POSTAL SERVICE

Standards Governing the Design of Curbside Mailboxes

ACTION: Final rule.

SUMMARY: The Postal Service is replacing USPS STD 7B, which governs the design of curbside mailboxes, with new USPS STD 7C. The new STD 7C was developed internally to meet the operational requirements of the Postal Service.

**TRADITIONAL MAILBOX
FIGURE 1A**

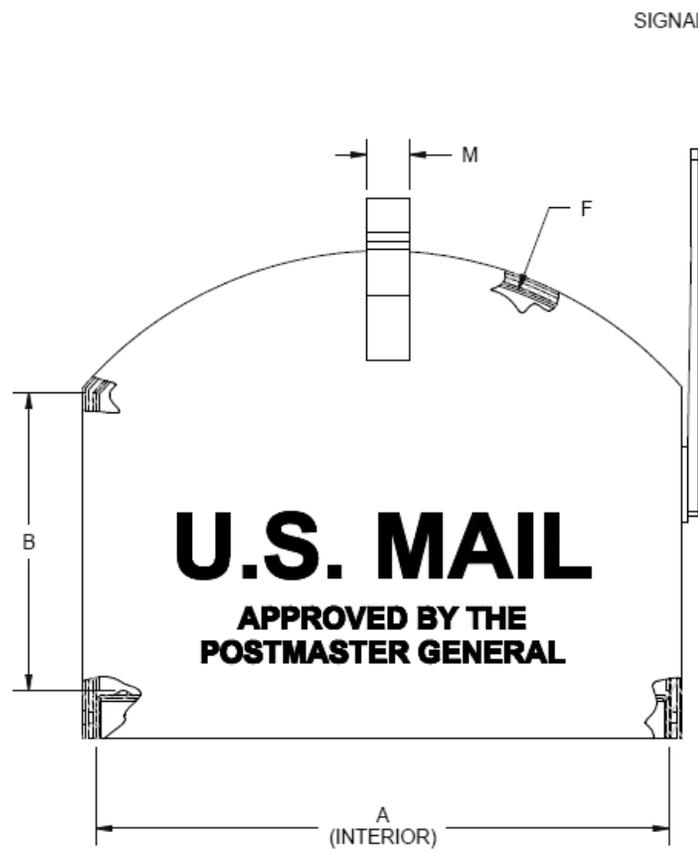
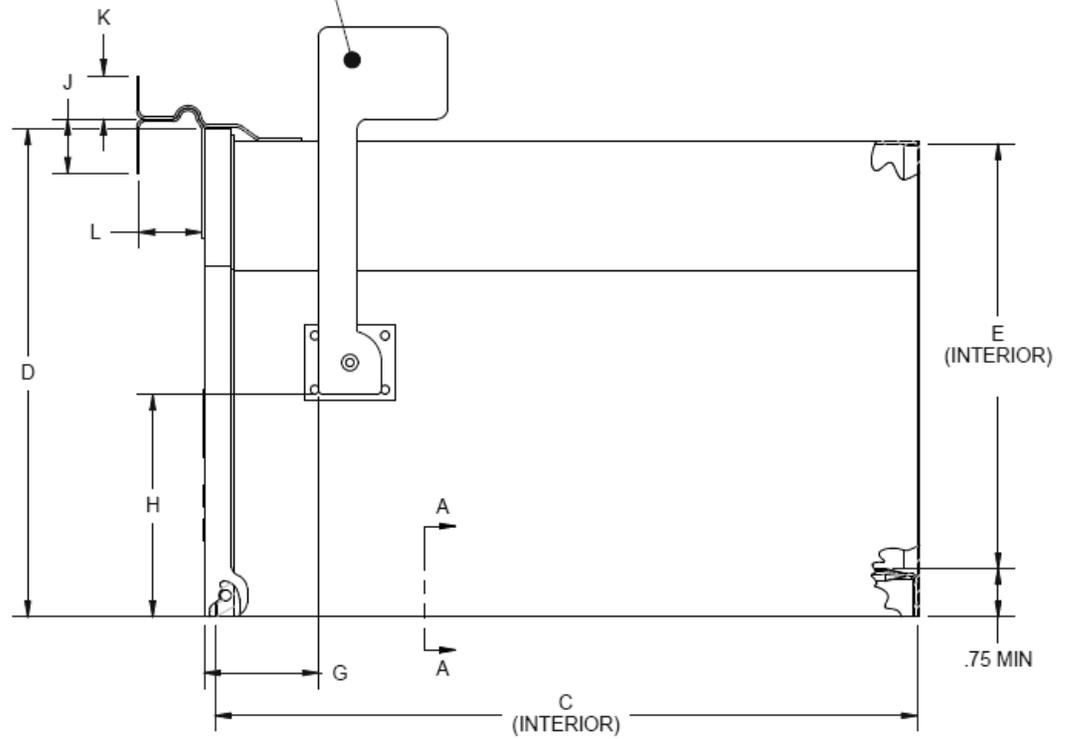
These comments also suggested the need for clarification of the requirements concerning the flag dimension for traditional mailboxes in Figure 1A, and more specificity regarding the requirement in section 3.9 that the color of the flag present a “clear contrast” with the predominant color of the mailbox. These suggestions were not accepted. We believe that such changes to longstanding requirements for boxes already approved under former STD 7B would not be appropriate in this context.

**LOCKED MAILBOX- MAIL SLOT DESIGN
(FULL SERVICE)
FIGURE 2A**

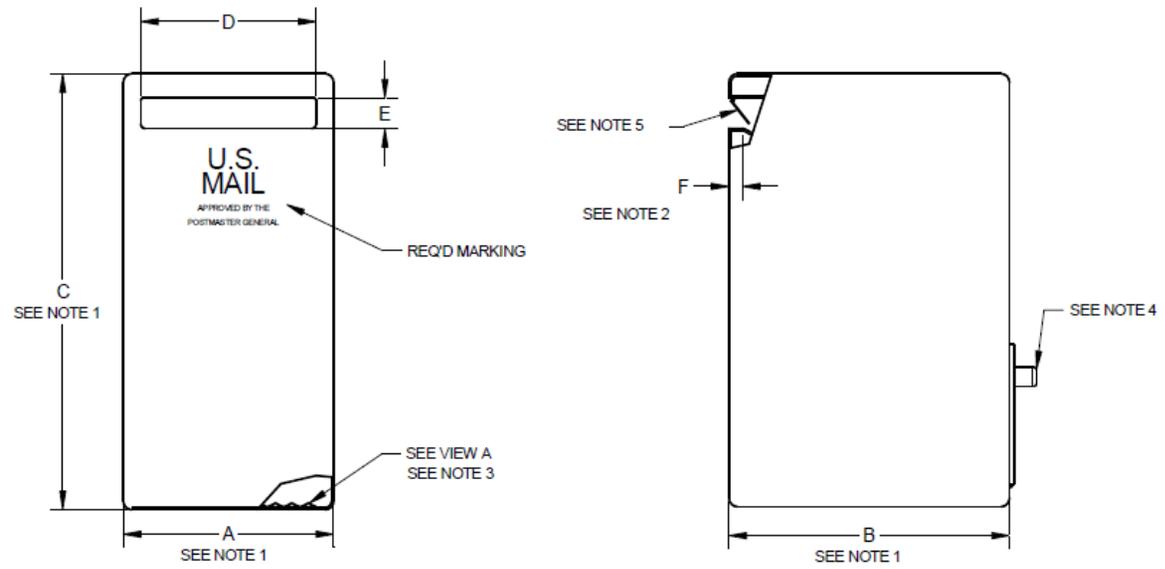
These comments further questioned the requirement in section 3.1.2.1 that the slot for a locked mailbox measure at least 1.75 inches high by 10 inches wide, suggesting that other shapes (such as a modified trapezoid) that allowed the insertion of the test gauges should be acceptable. This change was not accepted. We believe that the dimensions as proposed will facilitate the delivery of mail to the new boxes by simplifying the carrier’s task.

HANDLE/KNOB DESIGNS
FIGURE 5

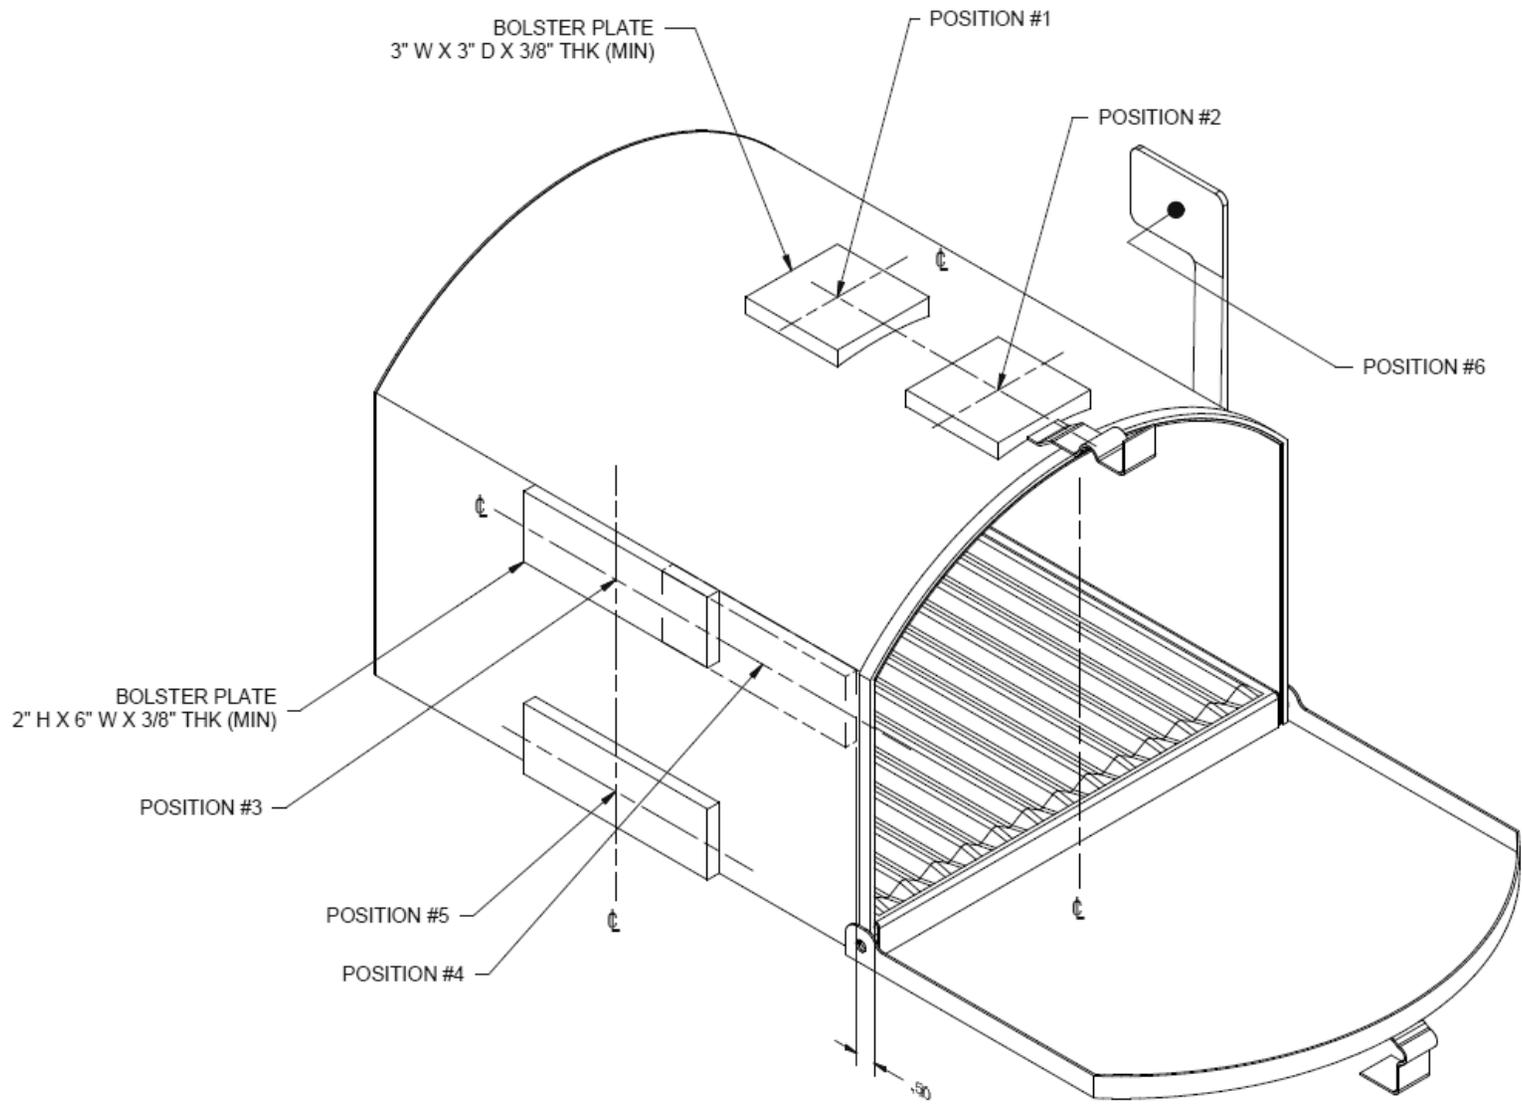
This set of comments also questioned the width of the mailbox door handles shown in design Figure 5 of the proposed standards, and suggested that they reflected a change from the current standards of USPS STD 7B. No such dimensional changes were intended, and Figure 5 has been reworked accordingly.
